<b>Product/Process Change Notice (PCN)</b>		
<input checked="" type="checkbox"/> Major Change <input type="checkbox"/> Minor Change		
<b>PCN Number:</b> PCN_WL-SUMW_20250201  <b>Affected Series:</b> WL-SUMW  <b>Affected Part Number:</b> 15335327CA452, 15335327CA554  <b>PCN Date:</b> 2024-11-01 (YYYY-MM-DD) <b>Effective Date:</b> 2025-02-01 (YYYY-MM-DD)	<b>Change Category:</b> <input checked="" type="checkbox"/> Equipment/Location <input type="checkbox"/> General Data <input checked="" type="checkbox"/> Material <input type="checkbox"/> Process <input checked="" type="checkbox"/> Product Design <input checked="" type="checkbox"/> Shipping/Packaging <input checked="" type="checkbox"/> Supplier <input type="checkbox"/> Software	
<b>Contact:</b> Product Management  <b>Phone:</b> +49 (0) 7942 - 945 5001  <b>Fax:</b> +49 (0) 7942 - 945 5179  <b>E-Mail:</b> pcn.eisos@we-online.com	<b>Datasheet Change:</b> <input checked="" type="checkbox"/> Yes <input type="checkbox"/> No  <b>Attachment:</b> <input type="checkbox"/> Yes <input checked="" type="checkbox"/> No

<b>DESCRIPTION OF CHANGE:</b> In line with internal standardisation, Würth Elektronik eiSos will update the product package. There

**15335327CA452**

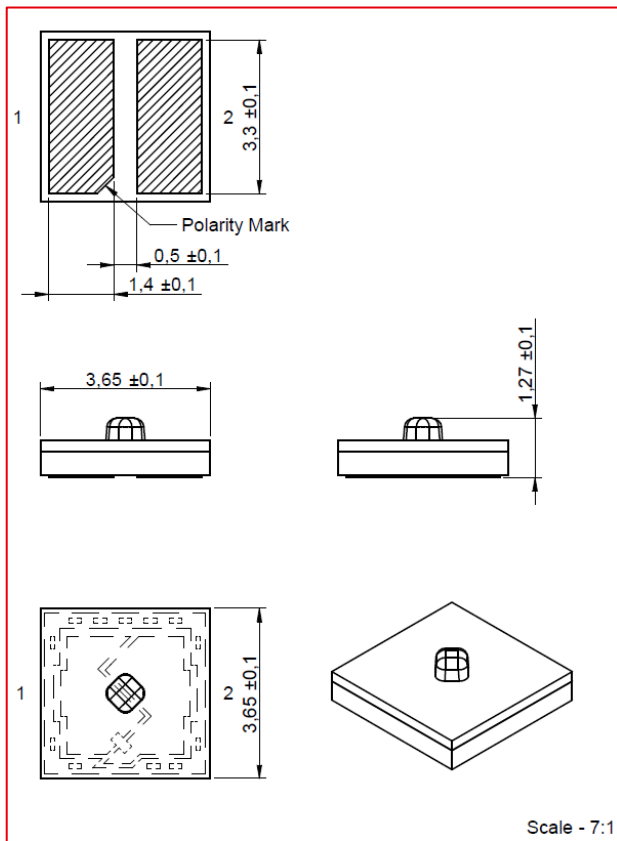
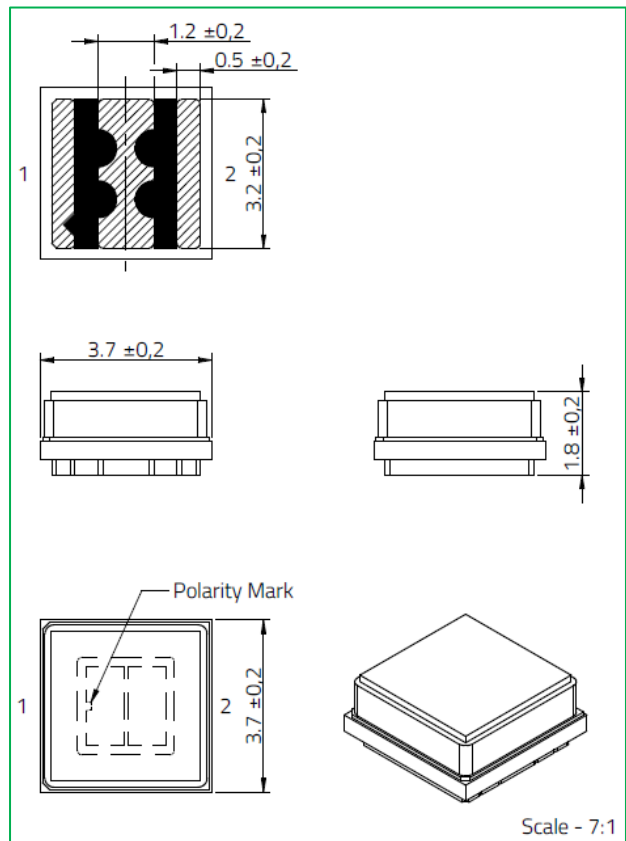
**Product dimension change:**

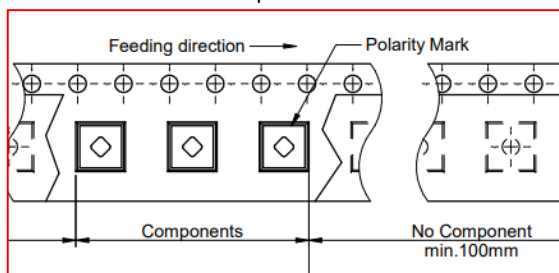
**Packaging drawing change:**

15335327CA452: 500pcs  
 15335327CA554: 250pcs

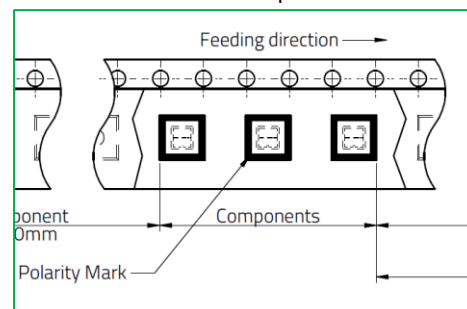
15335327CA452: 1000pcs  
 15335327CA554: 1000pcs
